2 REDLINE REVISION NO.2
6/6/2006
REPLACE LOOP FOR NB JUNIATA STREET WITH VIDEO DETECTION CAMERA.

MD 7A (REVOLUTION STREET) AND JUNIATA STREET

HAVRE DE GRACE, MARYLAND

TS NO. 1079 B | DRAWING NO. | OF | SHEET NO. 1 OF 2

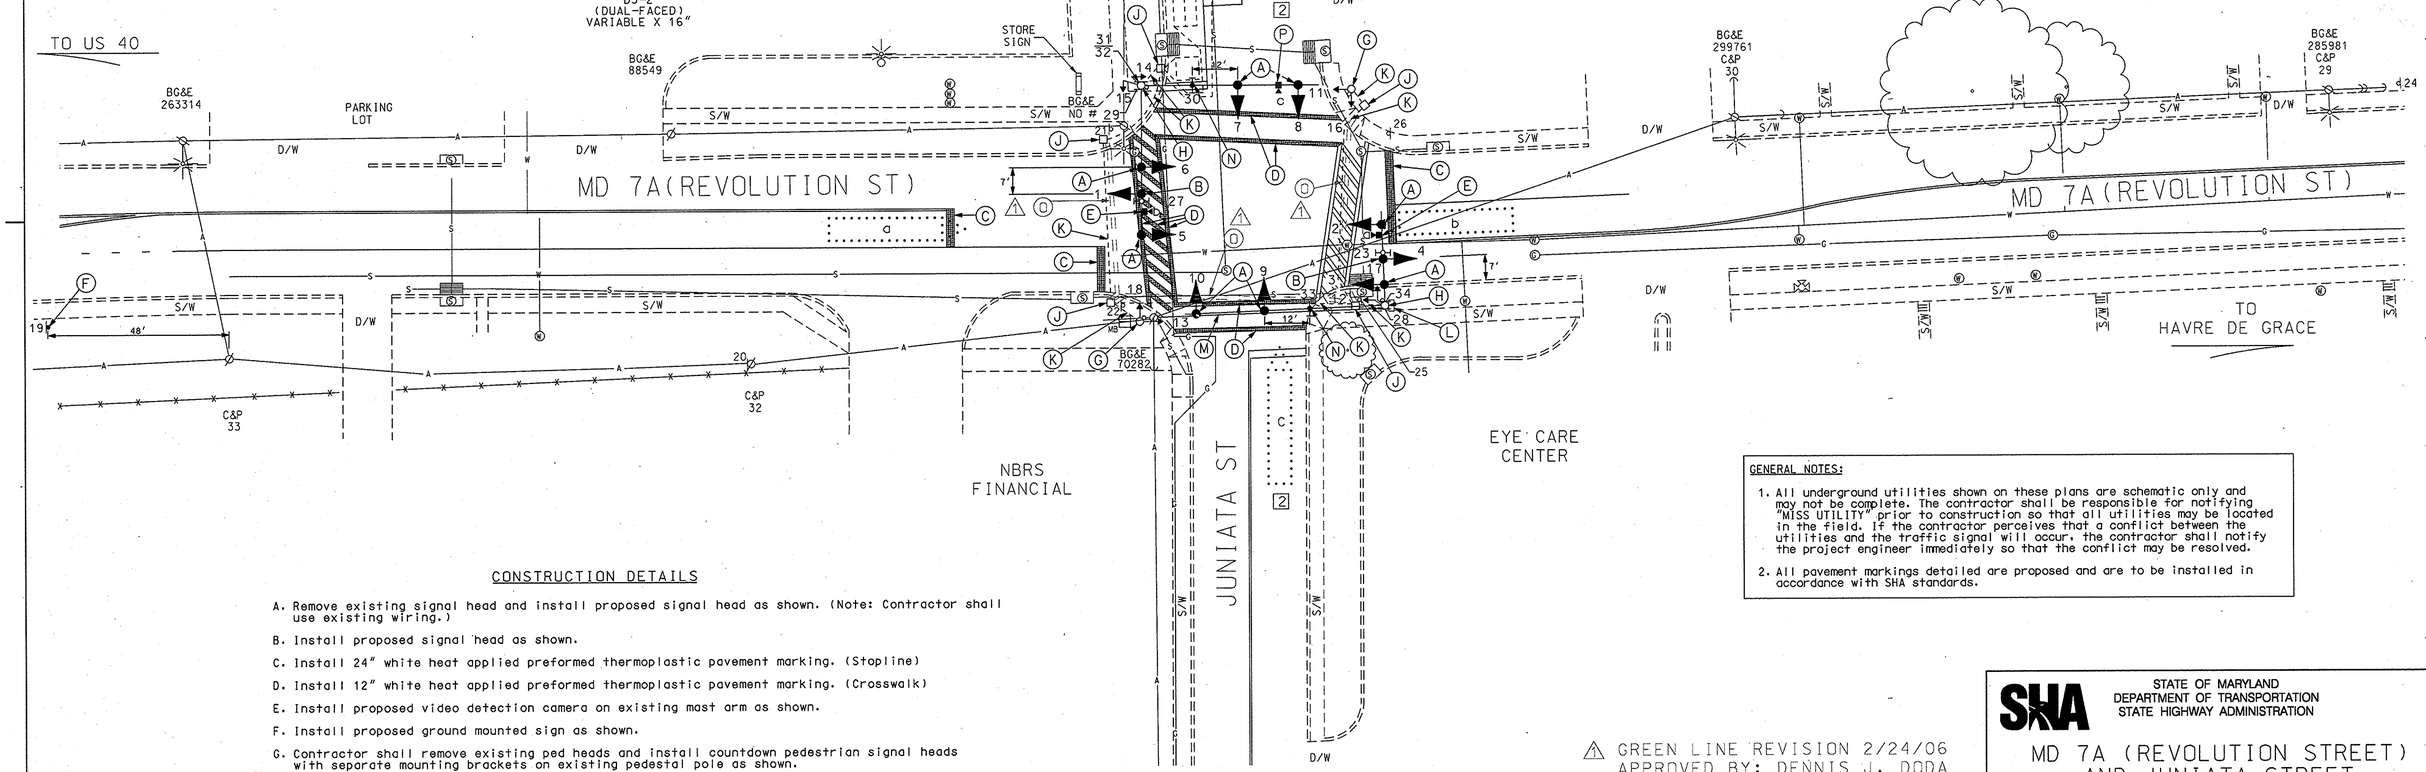
1 29 — WEST, MARYLAND 7 — M3-4 ~~30"x 15"~~ 24"x 12"; M1-5 ~~36"x 36"~~ 24"x 24"; M6-1 ~~30"x 24"~~ 21"x 15" — ASSOCIATED SHIELD ASSEMBLY ~~36" x 75"~~ 24" x 51"

1 34 — EAST, MARYLAND 7 — M3-2 ~~30"x 15"~~ 24"x 12"; M1-5 ~~36"x 36"~~ 24"x 24"; M6-1 ~~30"x 24"~~ 21"x 15" — ASSOCIATED SHIELD ASSEMBLY ~~36" x 75"~~ 24" x 51"

2 — VIDEO DETECTION CAMERA (a,b,c) (Exact location and orientation of camera to be determined with Project Engineer's approval).

J. Use existing handhole.
K. Use existing conduit.
L. Use existing cabinet and controller.
M. Maintain existing overhead service by BGE
N. Install overhead sign on existing mast arm as shown.
1 O. Install 4" polyvinyl chloride electrical conduit (Schedule 80) (slotted). (Note: Route new Countdown Pedestrian cable, video camera cable and cable for signal # 1 through this conduit).
2 P. Install proposed video detection camera on existing mast arm as shown.

1 REDLINE REVISION NO.1
1/27/2006
MODIFY SHIELD ASSEMBLY SIGN SIZE.
